TO: Mercedes-Benz Dealer Principals, General Managers, Sales Managers, Service Managers, Parts Managers	FROM: Gregory Gunther, Senior Manager, Vehicle Compliance and Analysis, Engineering Services
RE: Recall Campaign Launch Notification Replace Fuel Pump Delivery Module – Wave 5 MY21-24 C-Class, E-Class, S-Class, SL, GT, GLC, GLE, GLS and G-Class (205/206, 213/238, 223, 232, 290, 253/254, 167 and 463 platforms)	DATE: September 20, 2024

Recall Campaign Bulletin

Campaign No. 2024010011, July 2024

Replace Fuel Pump Delivery Module – Wave 5

Figure 2

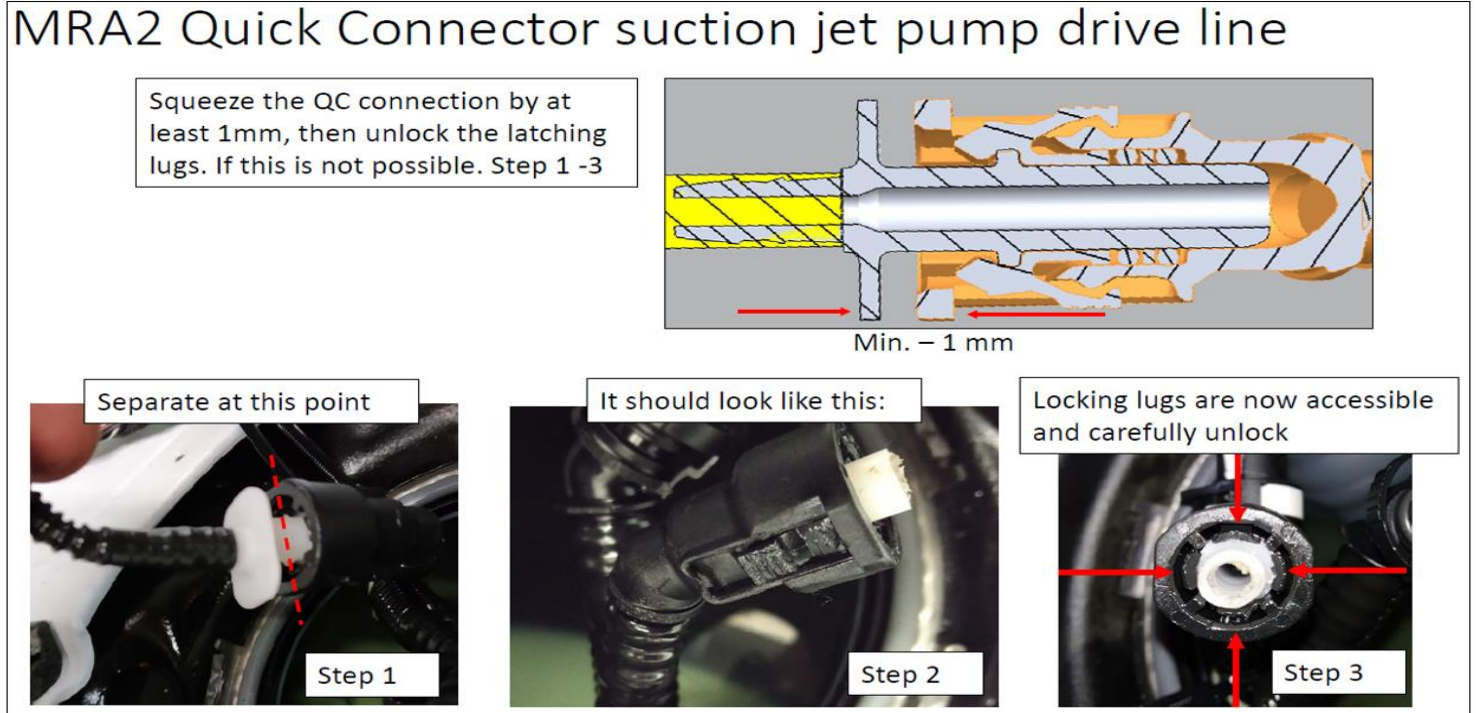
i Only model 206, 232: Note on disassembly of suction jet pump drive line quick connector.

The procedure steps 1-3 should only be performed when the quick disconnect is not working (**Figure 2**).

Figure 4 (remove electric lines from routing clip)

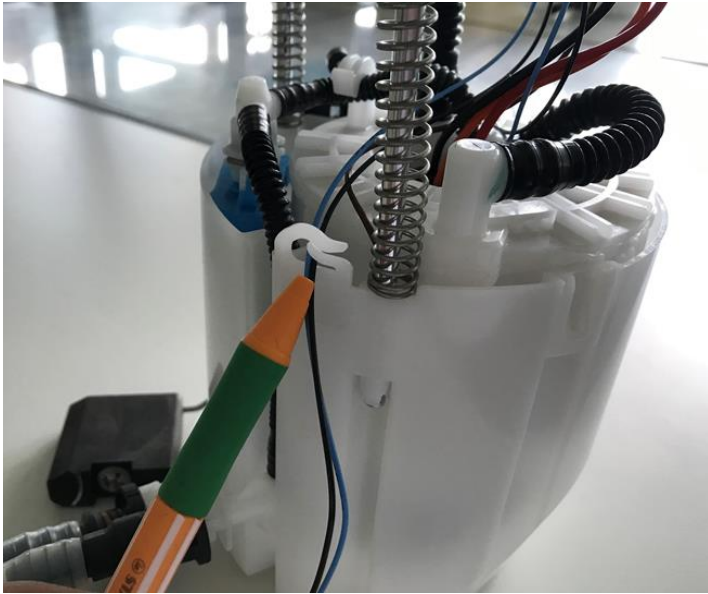
i Delivery modules that are delivered **without float-and-lever sensor** must be modified. (**Figure 4-7**)
